RE: Walden Eco Village
360 Middle Hancock Road
Peterborough, New Hampshire

GeoInsight, Inc. (GeoInsight) is providing this letter to summarize our review of hydrogeologic conditions and the review of wetlands mapping for the project referenced above. The Town of Peterborough (the Town) Planning Board (the Board) is currently reviewing an application for subdivision prepared by Fieldstone Land Consultants located at the address referenced above. You have provided GeoInsight with a copy of the proposed development plans and a scope of work dated June 13, 2021. Review of the wetlands mapping was provided by West Environmental, Inc. (WEI) and their review letter is included as Attachment A.

Re: Wetland Delineation Review Walden Eco-Village

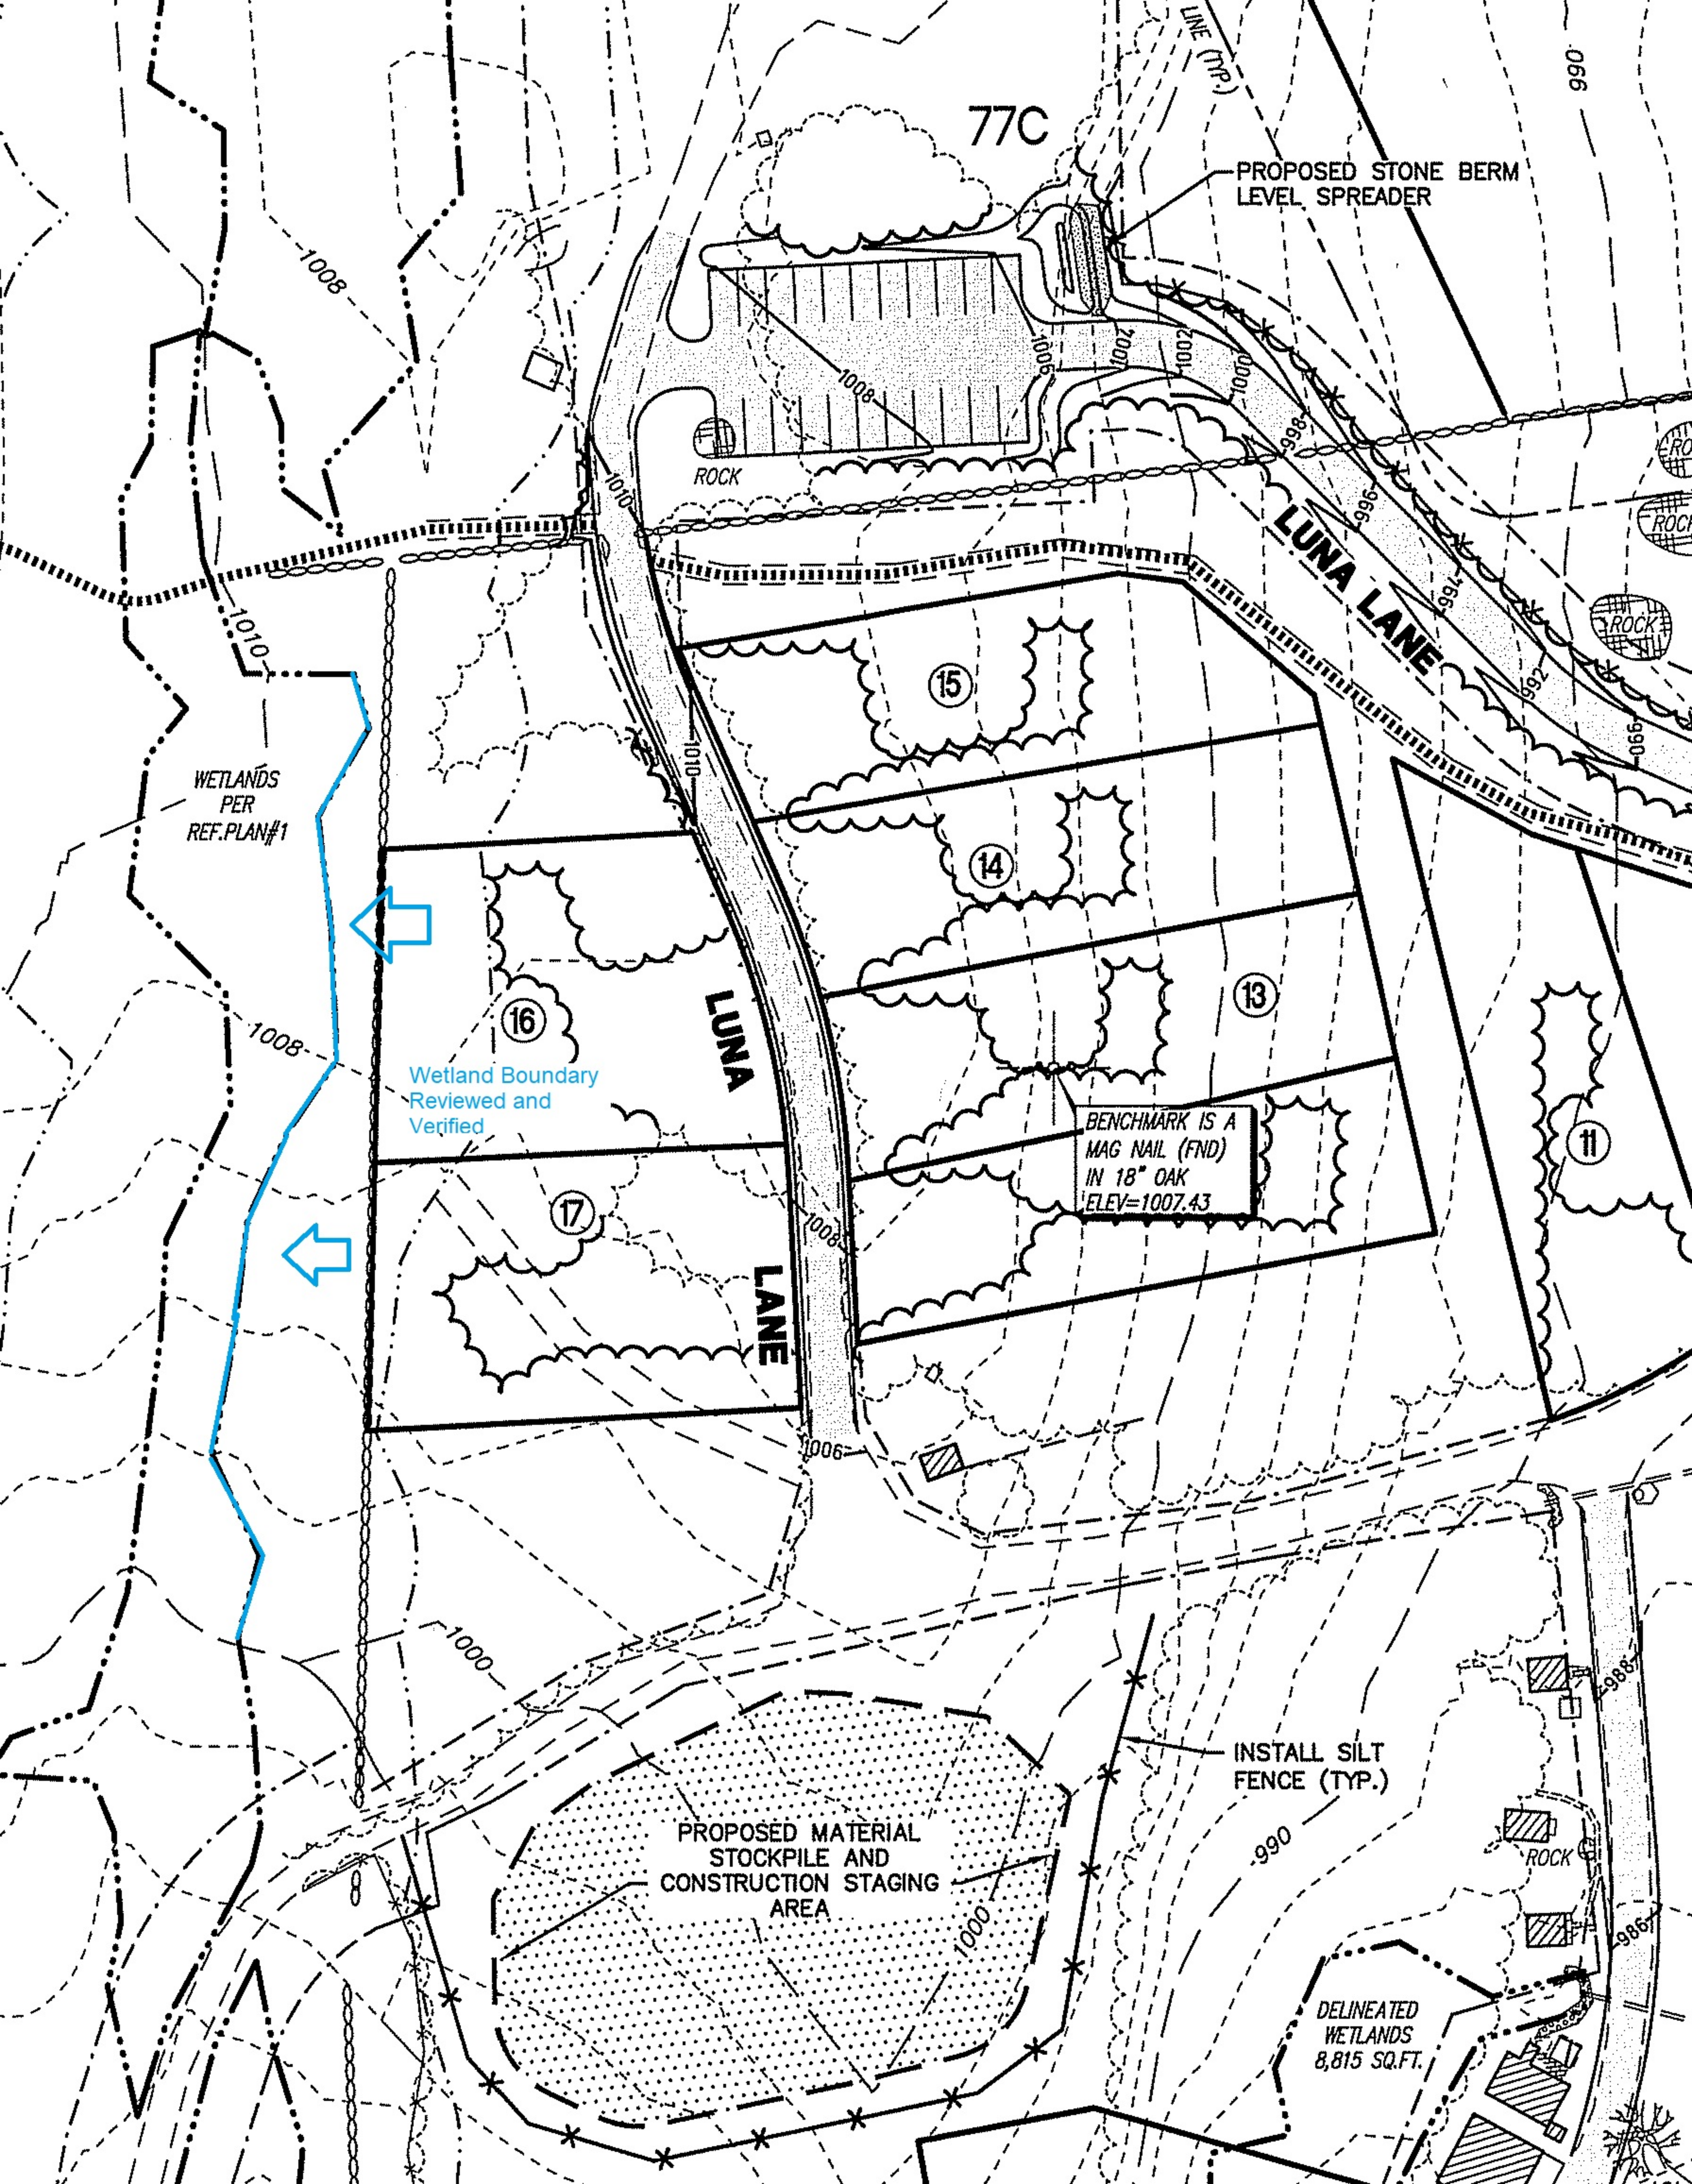
We also reviewed the area identified on Attachment B because Lots 16 and 17 west of Luna Lane are adjacent the 50-foot setback of the wetland. These flags were still in place and the wetland boundary shown in blue on the attachment was verified to be accurate.

WETLAND WORKSHEET
WALDEN ECO VILLAGE
CONSOLIDATED TAX MAP R010 LOT 005-001
(MIDDLE HANCOCK ROAD)
PETERBOROUGH, NEW HAMPSHIRE
 PREPARED FOR:
AKHIL GARLAND
 P.O. BOX 54, HARRISVILLE, NH 03450
 LAND OF:
GARLAND FAMILY REALTY TRUST
 P.O. BOX 54, HARRISVILLE, NH 03450

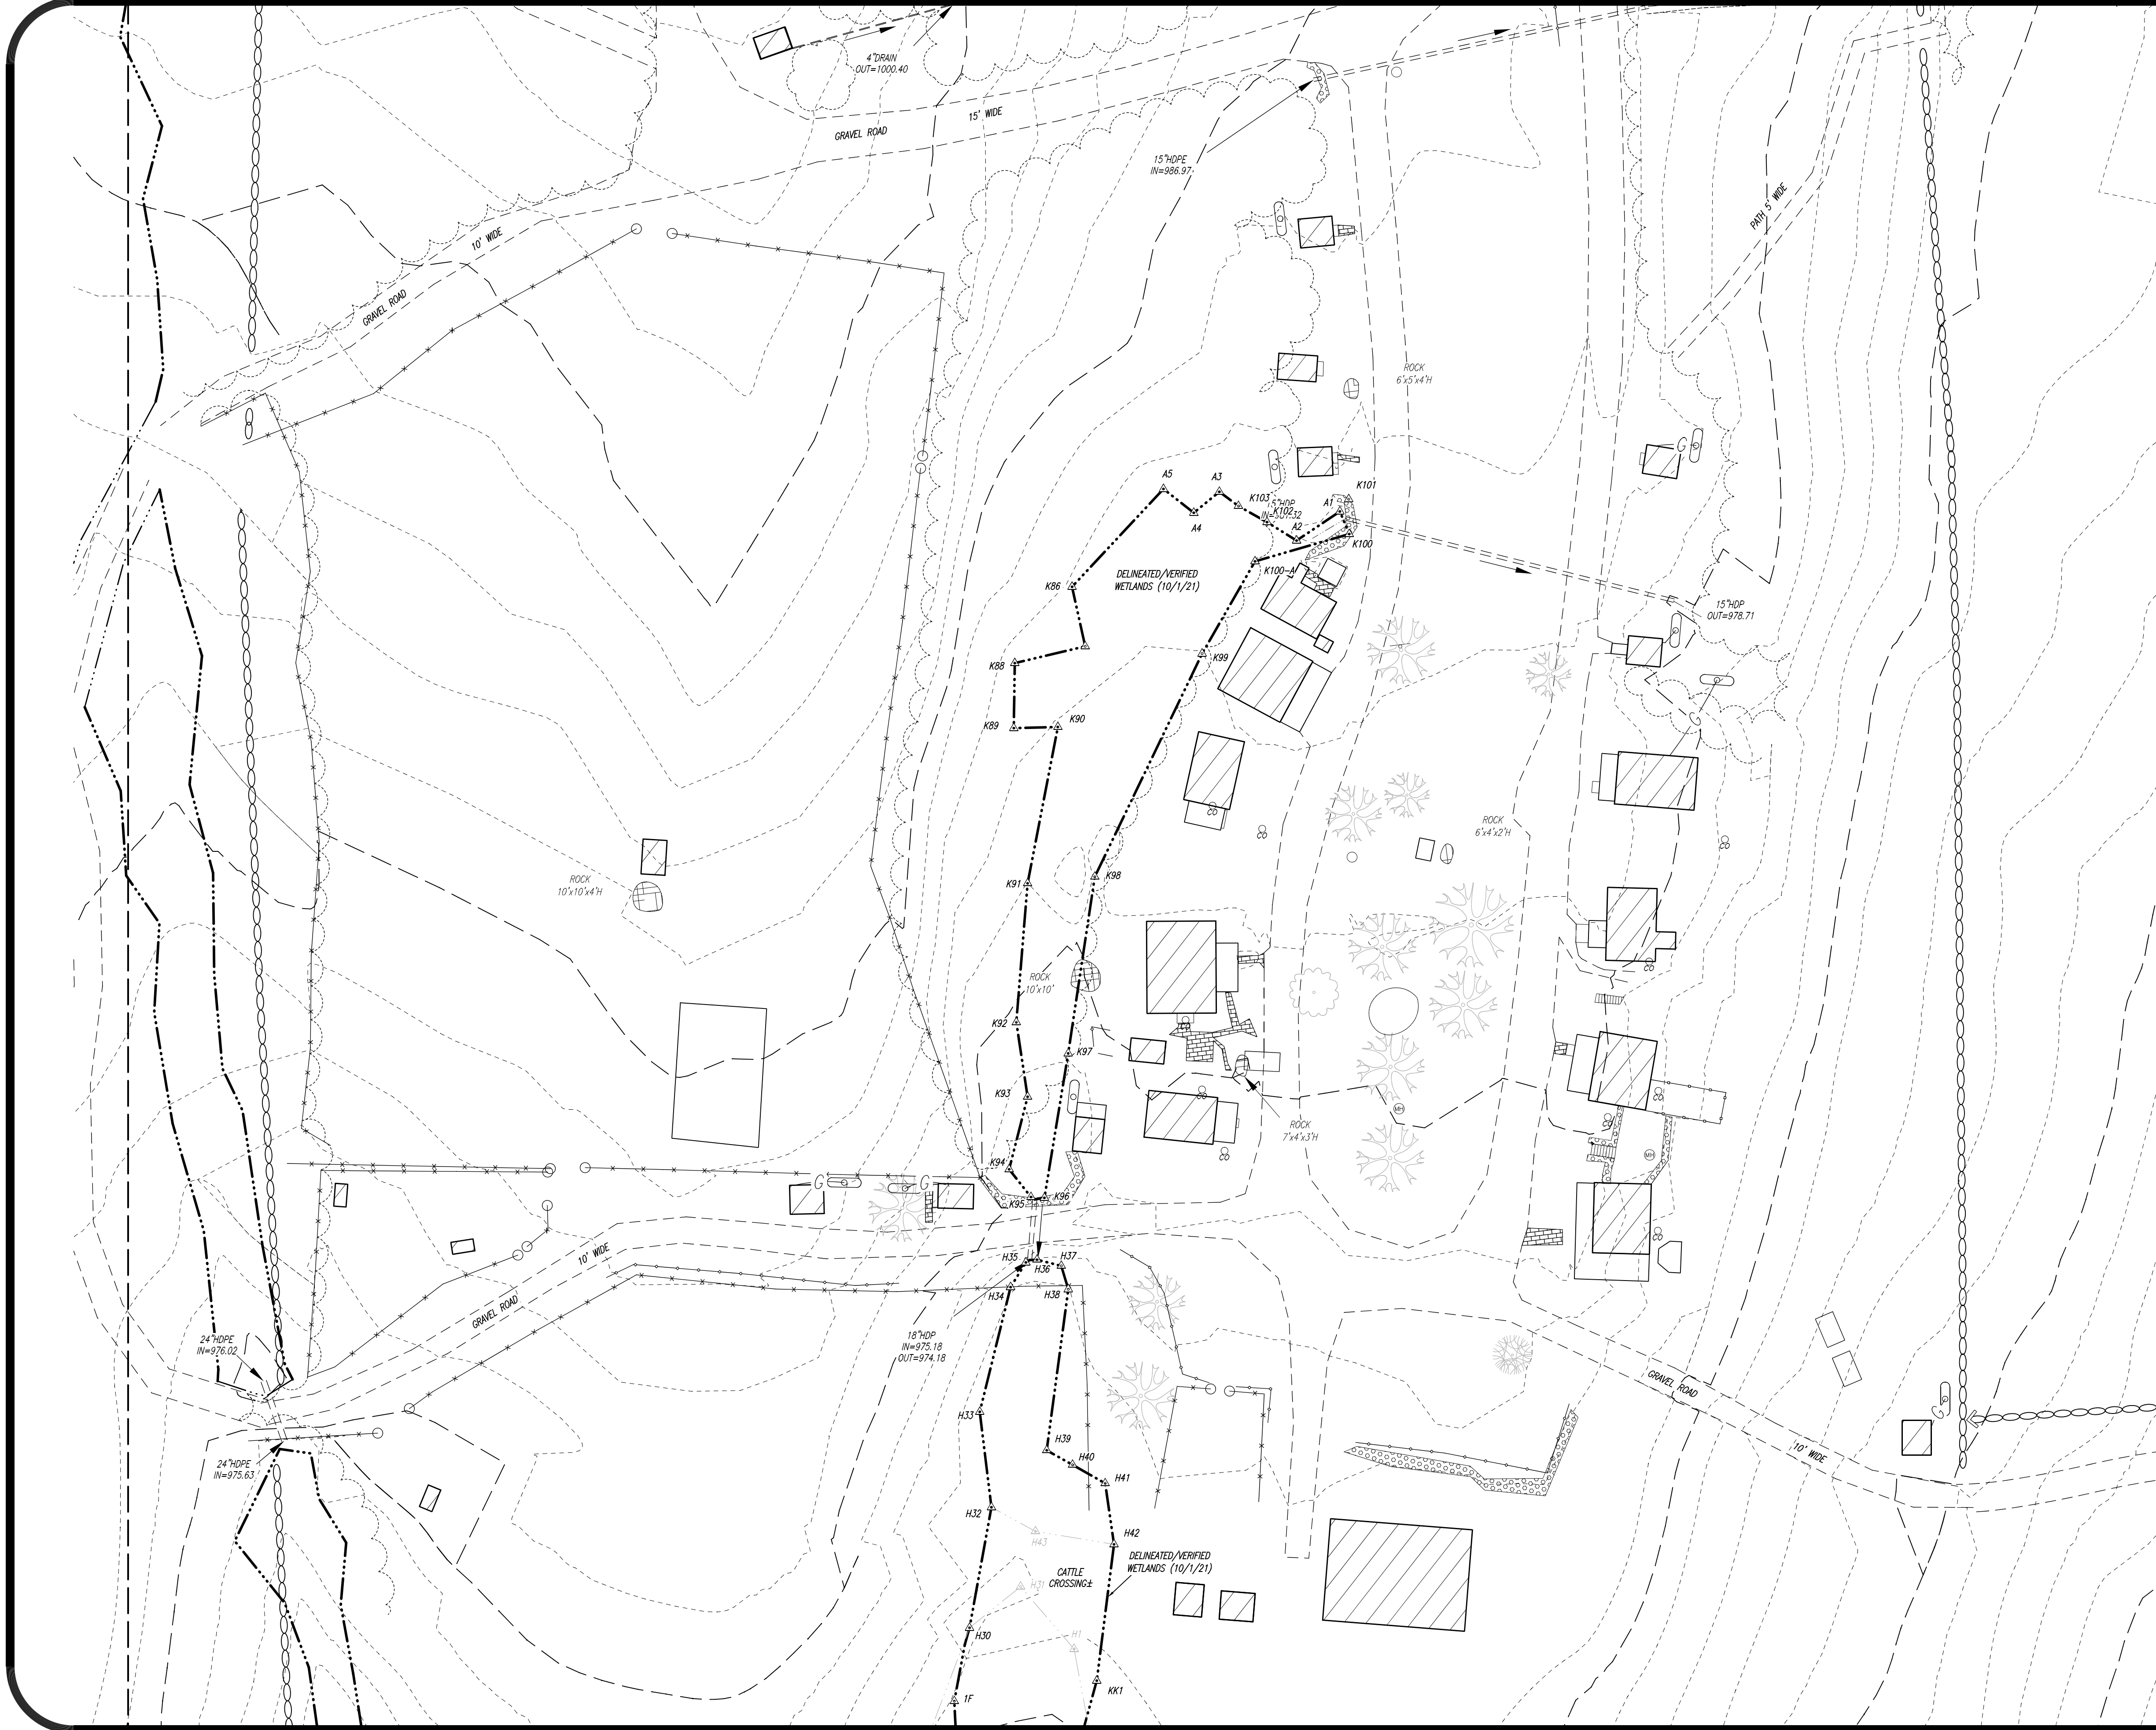
We evaluated soil probes, evidence of wetland hydrology and plant communities to determine the edge of wetland. **These verified wetlands are shown on the attached Wetland Worksheet WK-1 prepared by Fieldstone Land Consultants dated November 17, 2021, and accurately reflect the wetland boundaries.**
